POST OFFICE BOX 61  
PETALUMA, CA 94953-0061  
ADDENDUM NO. 2

## PETALUMA TURNING BASIN FLOATING DOCK City Project Number C14402010

March 8, 2023

SHEET  
**C-102**  
4 OF 6

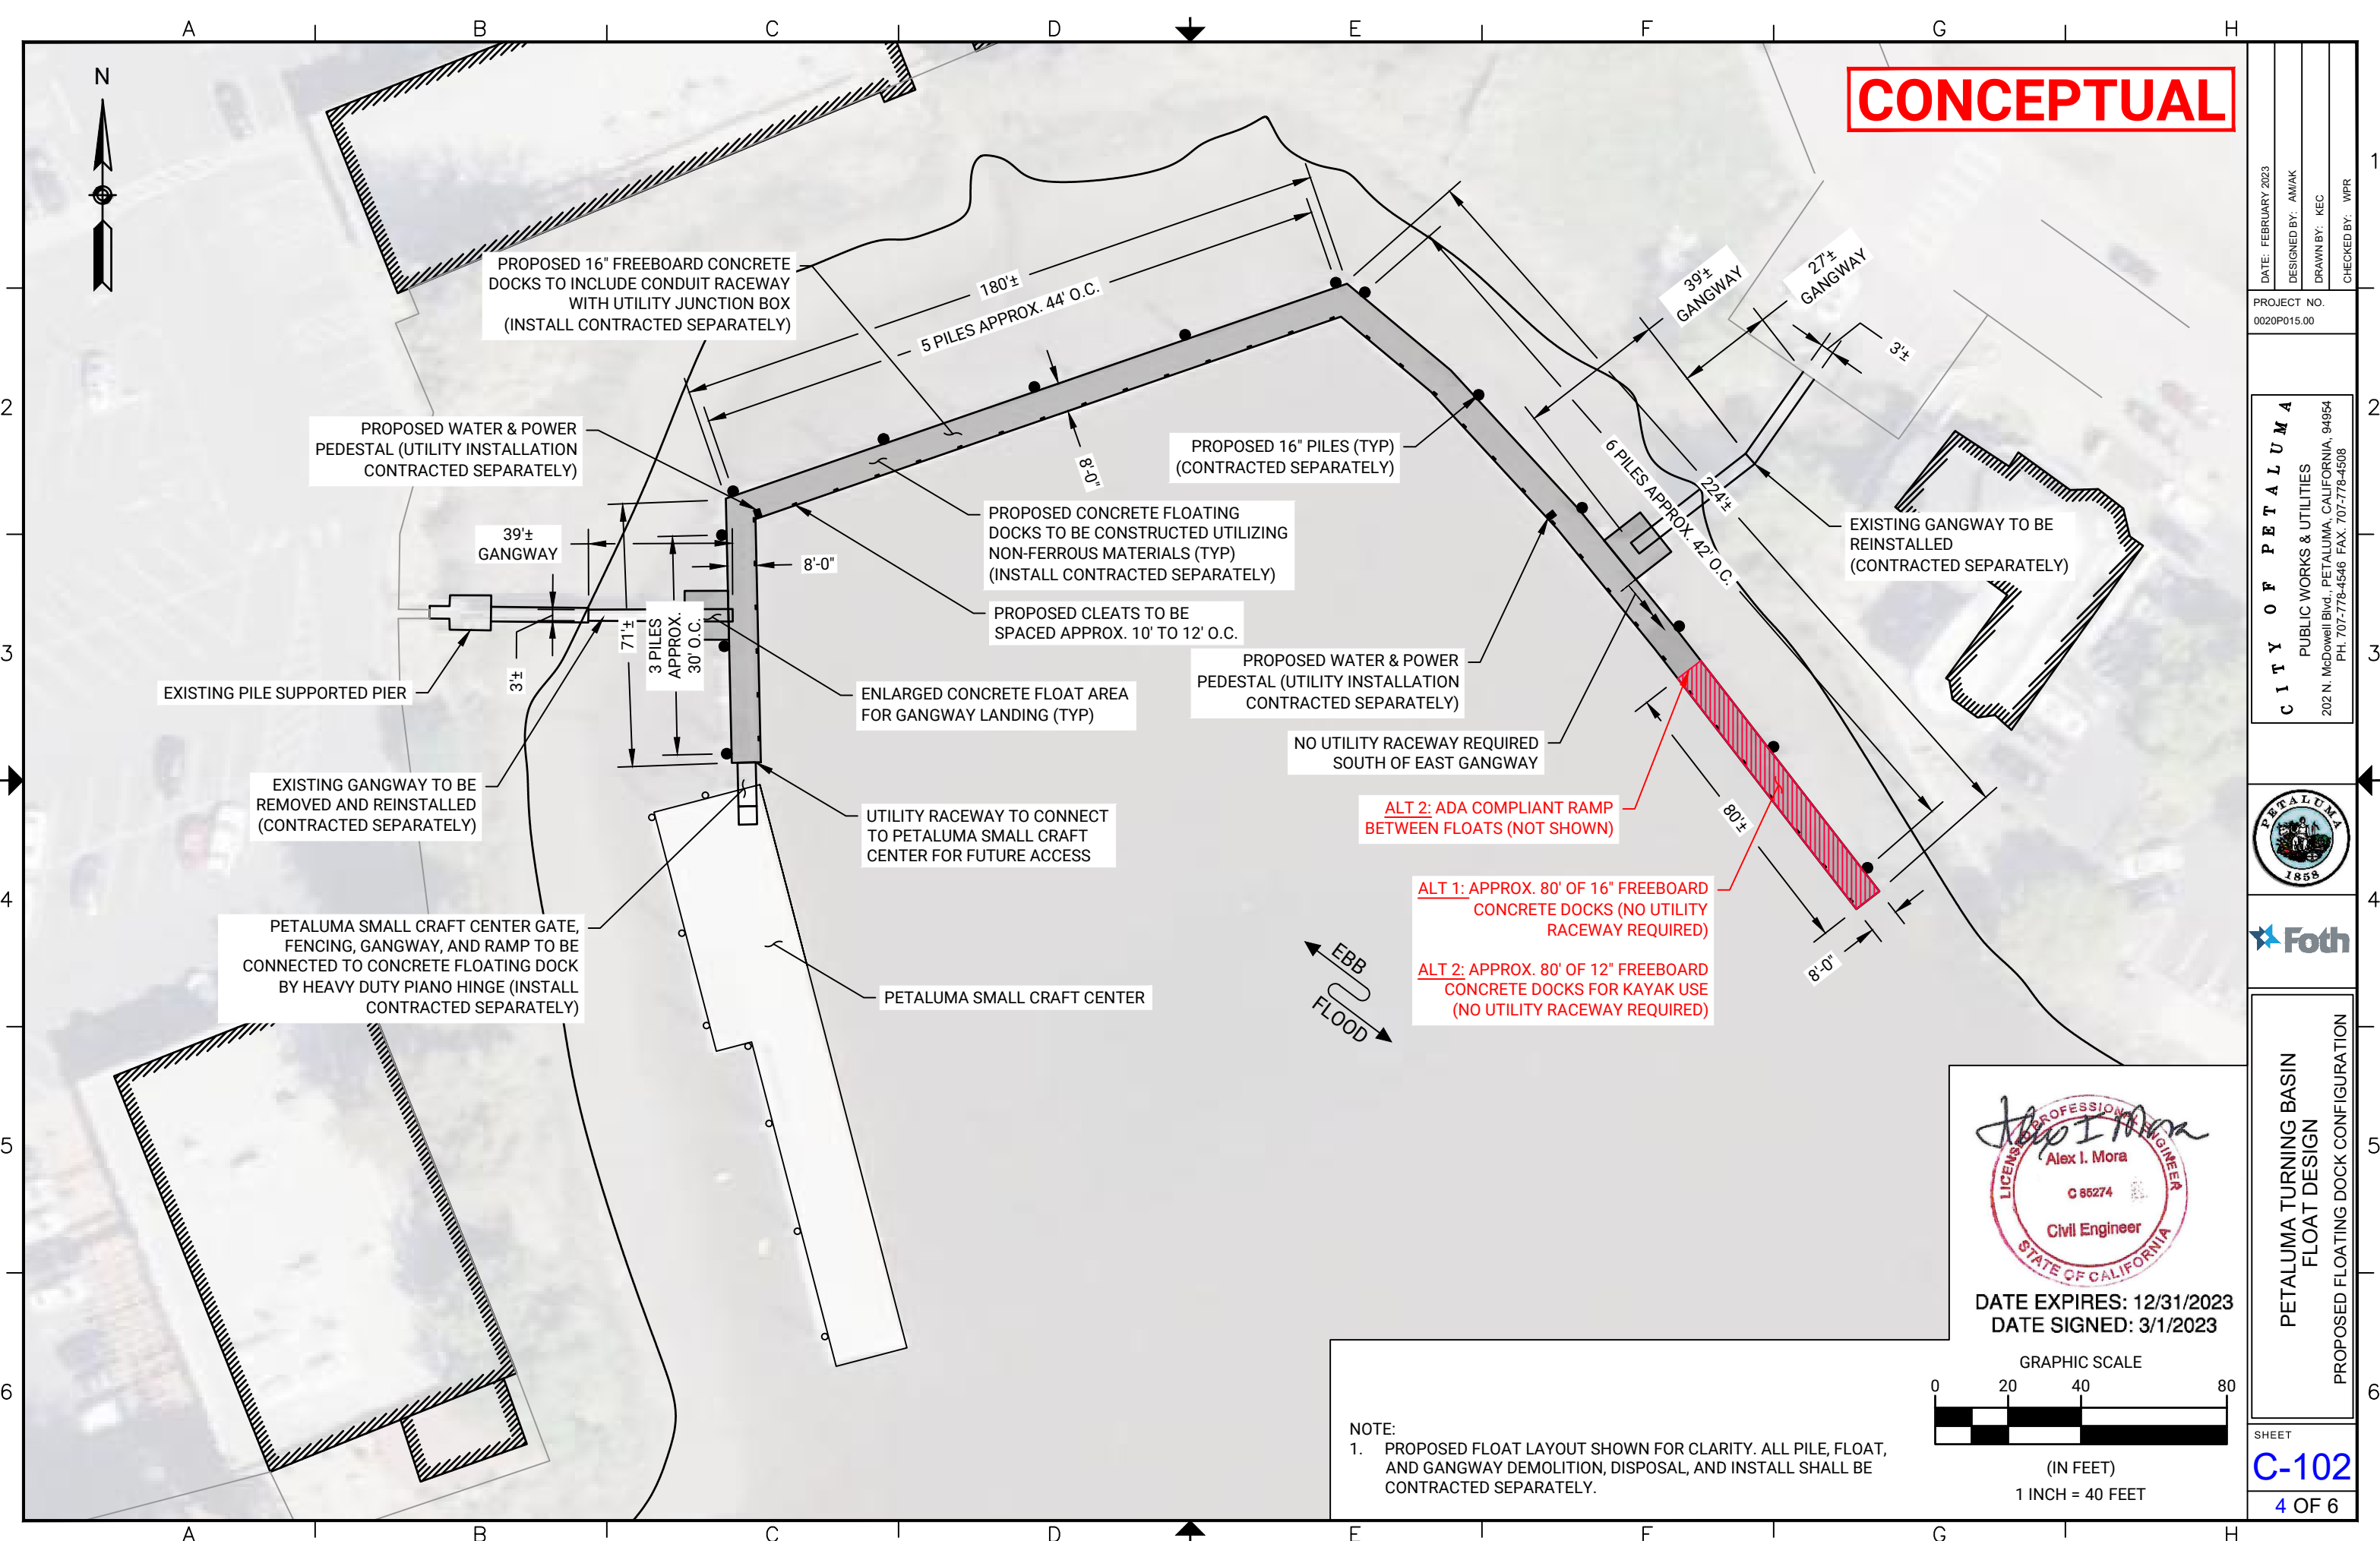
**PETALUMA TURNING BASIN FLOATING DOCK DESIGN & FABRICATION PLANS  
– SHEET C-102 – REVISE**

**Q:** *Sheet C-102 of the Plans show the existing gangway to Petaluma Small Craft Center Gate and Gangway to be reused. Can the city provide a detail for the gangway hinge connection? Can the city provide the weight of the existing Petaluma Small Craft Center Gate to be reused and connection details?*

**A:** Please see attached.

SHEET  
**C-103**  
5 OF 6

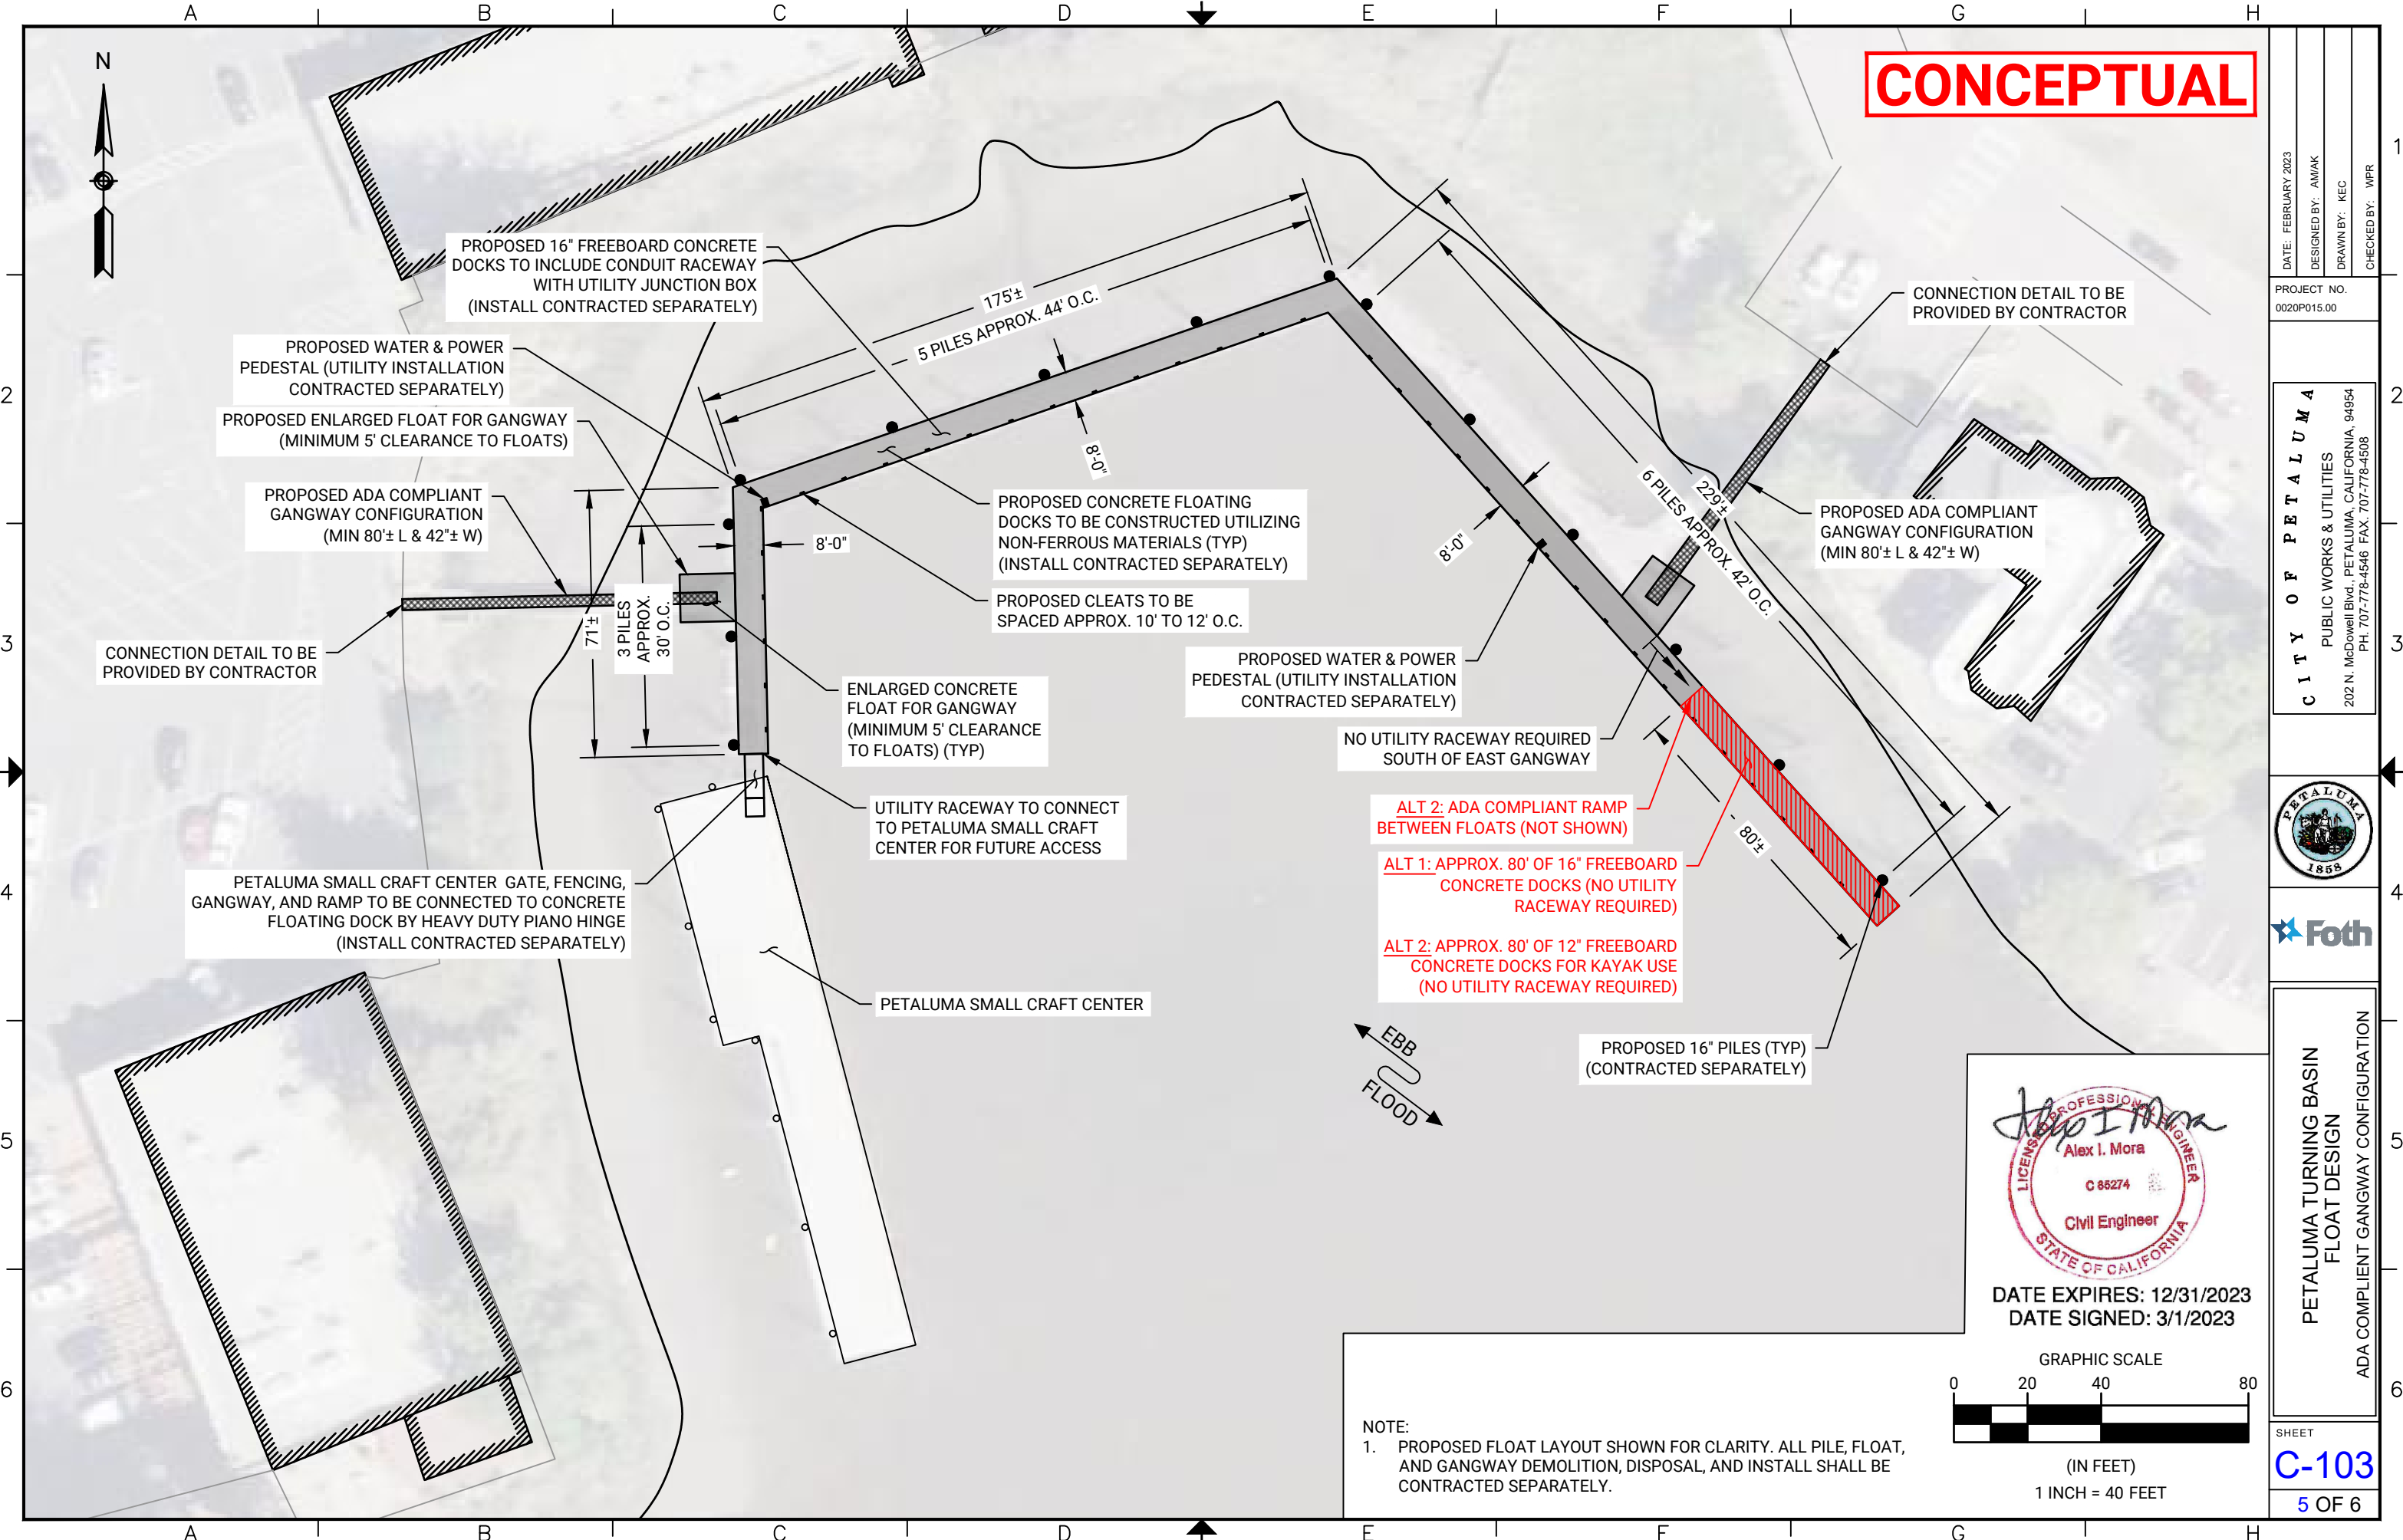
**PETALUMA TURNING BASIN FLOATING DOCK DESIGN & FABRICATION PLANS  
– SHEET C-103 – REVISE**

**A**  
5  
TYPICAL FLOAT DETAIL  
SCALE: 1" = 60'

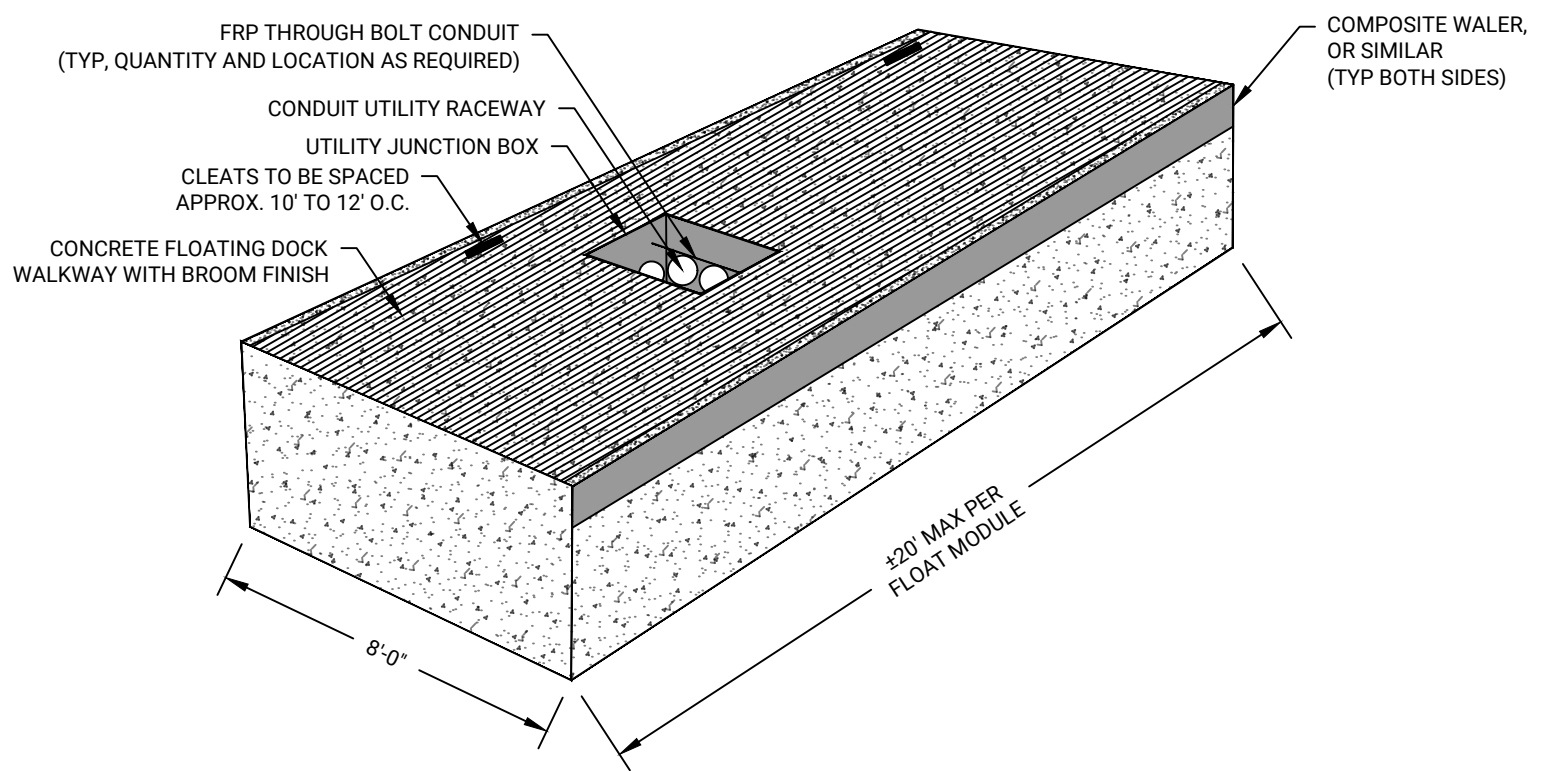
**PETALUMA TURNING BASIN FLOATING DOCK DESIGN & FABRICATION PLANS  
– SHEET D-101 – DETAIL A – REVISE**

**Q:** *Can the contractor assume this is a typo since the floating docks are made with Expanded Polystyrene Core (EPS)?*

Expanded Polystyrene Core (EPS) shall be used.

**A:** Expanded Polystyrene Core (EPS) shall be used.
